MEETING AGENDA

Appearance Commission

A. **Public Meeting** for Case 25-50: Appearance Review, Raising Cane's Restaurant at 17950 Halsted Street

PH1.0
SHEET NUMBER:

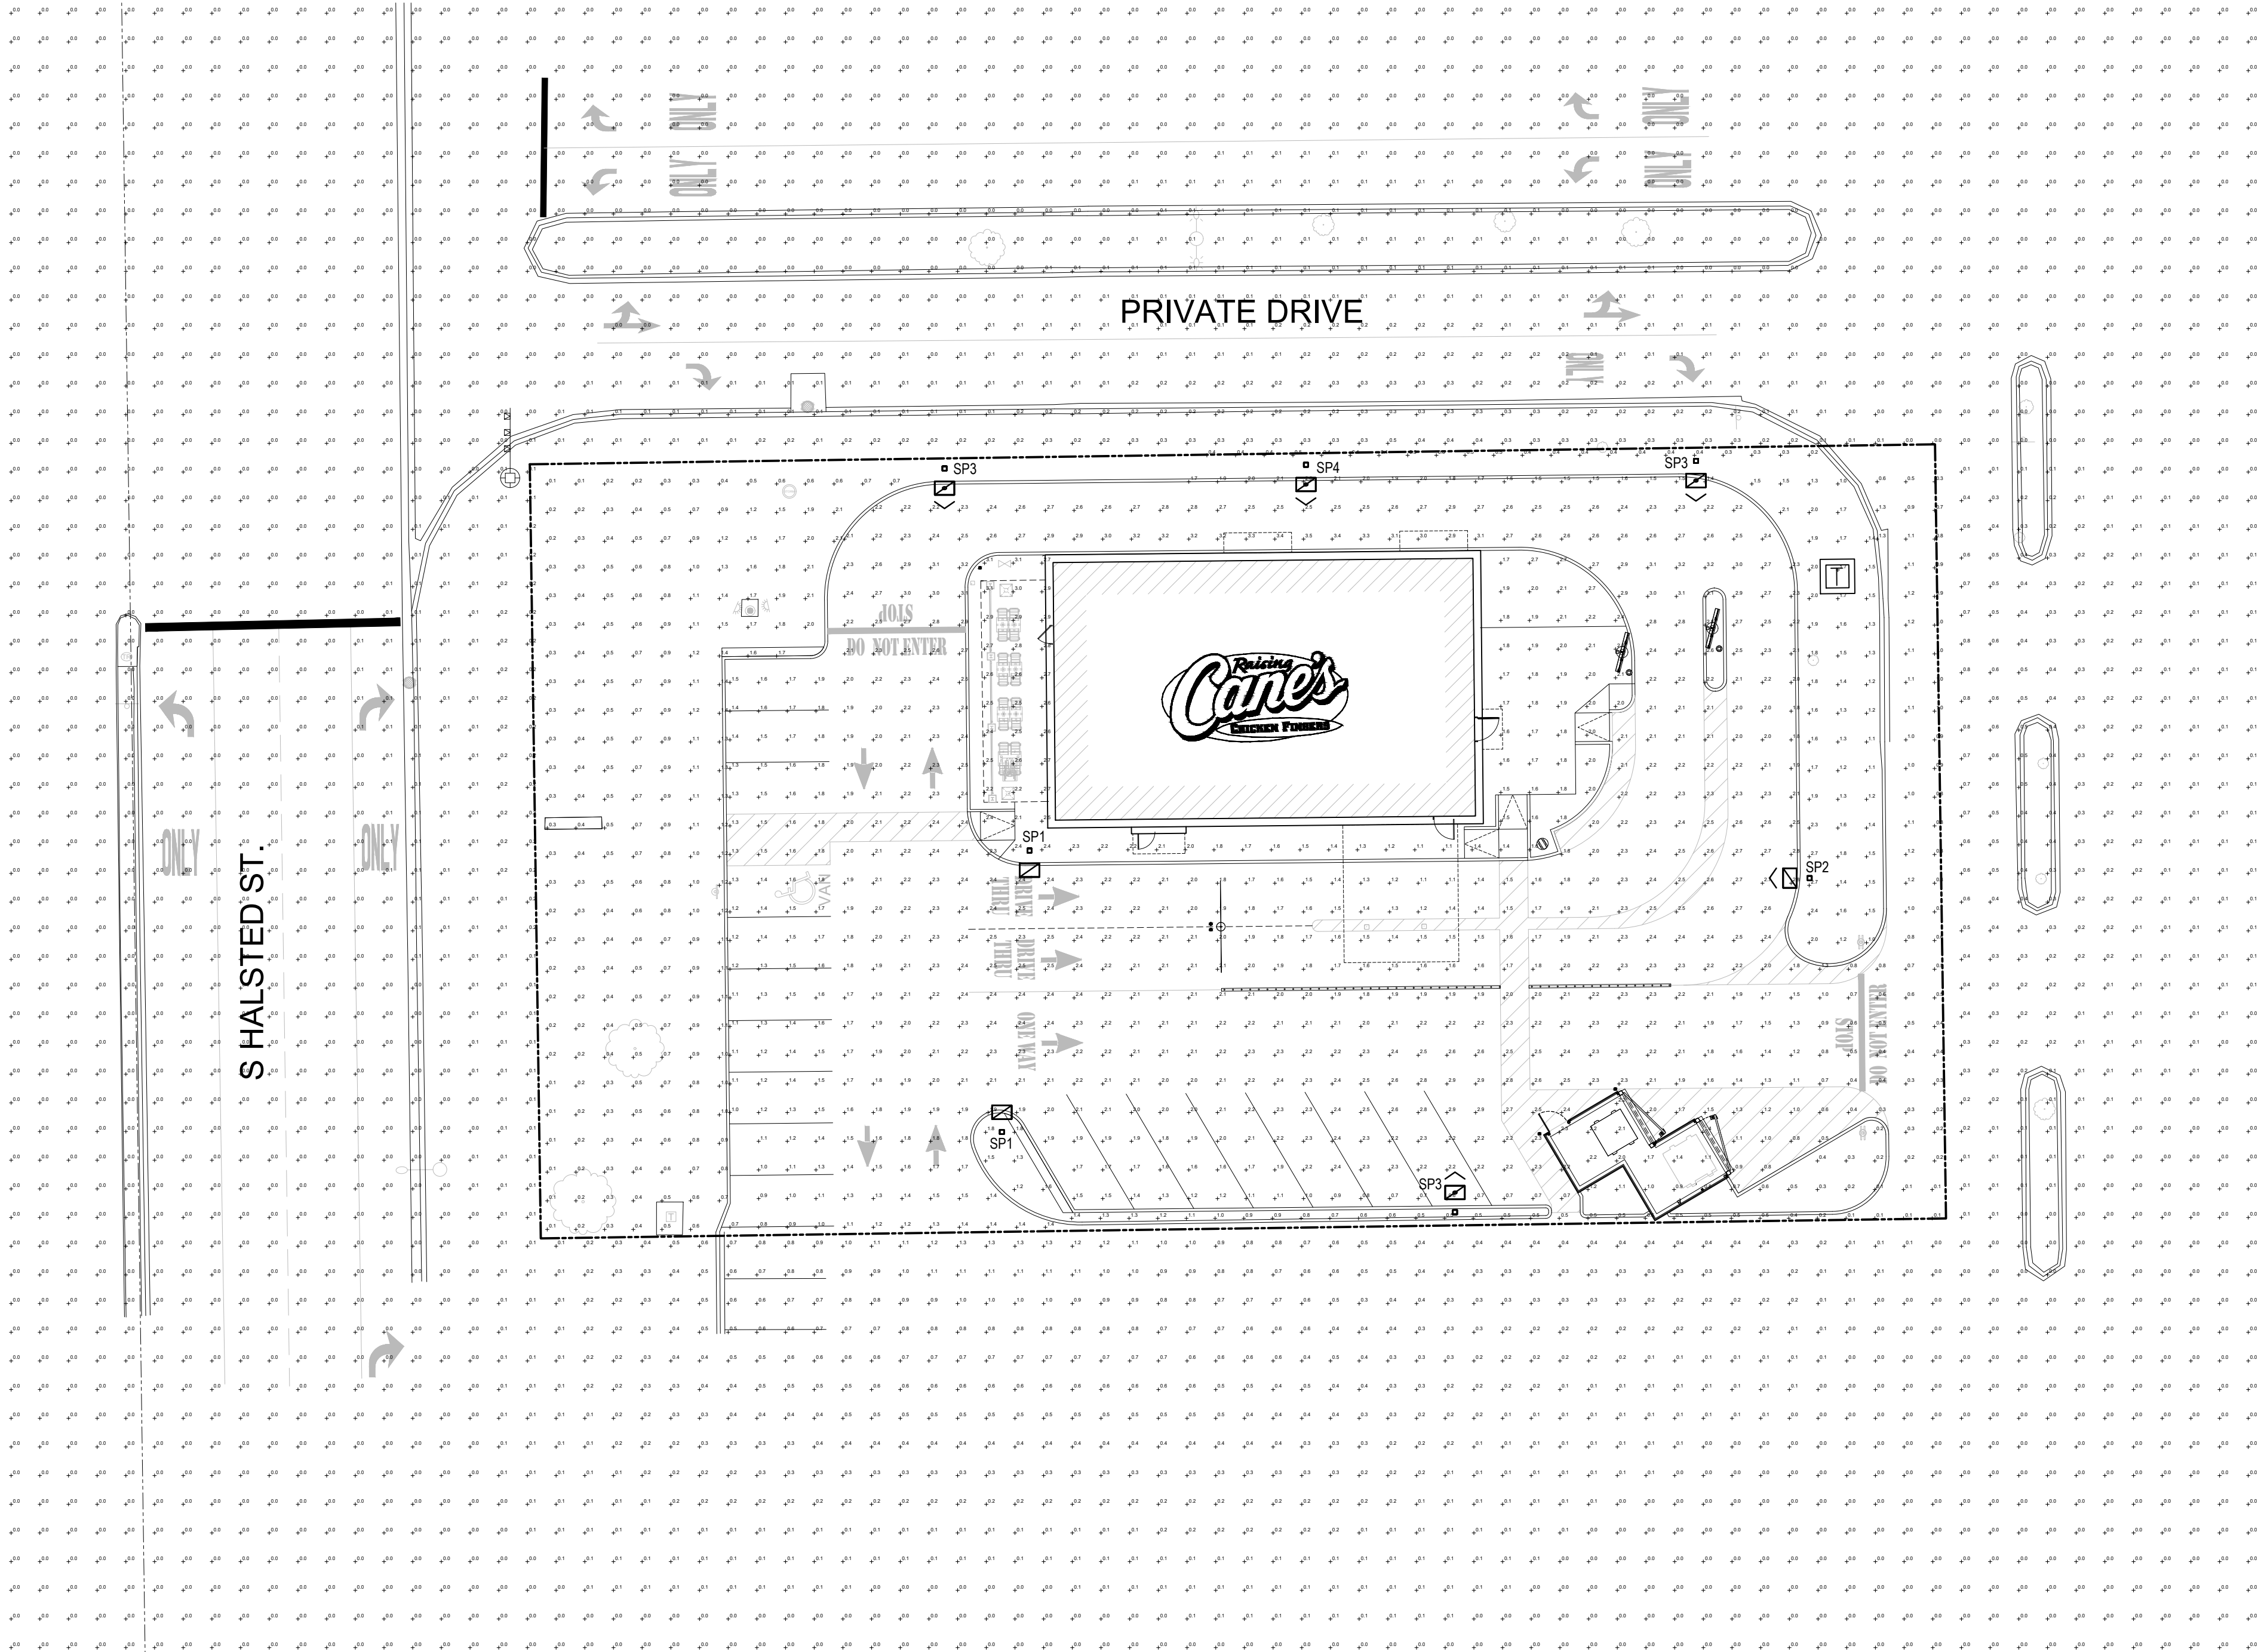
The applicant has proposed to replace all site lighting, including exterior building lighting and parking lot lighting. The applicant has proposed to remove the existing arm sconces along the sides of the building, to be replaced with modern cylindrical sconce lights. The applicant has proposed six 20' parking lot lighting poles around the perimeter of the site, with an additional lighting pole located near the building. Additional exterior recessed lighting will also be provided within proposed building canopies.

1. Revise photometric plan with relocated lighting fixtures to reduce lighting impacts on neighboring property to less than 0.5 footcandles in conformance with the Village Zoning Ordinance.

8. Revise photometric plan with relocated lighting fixtures to reduce lighting impacts on neighboring property to less than 0.5 footcandles in conformance with zoning requirements.
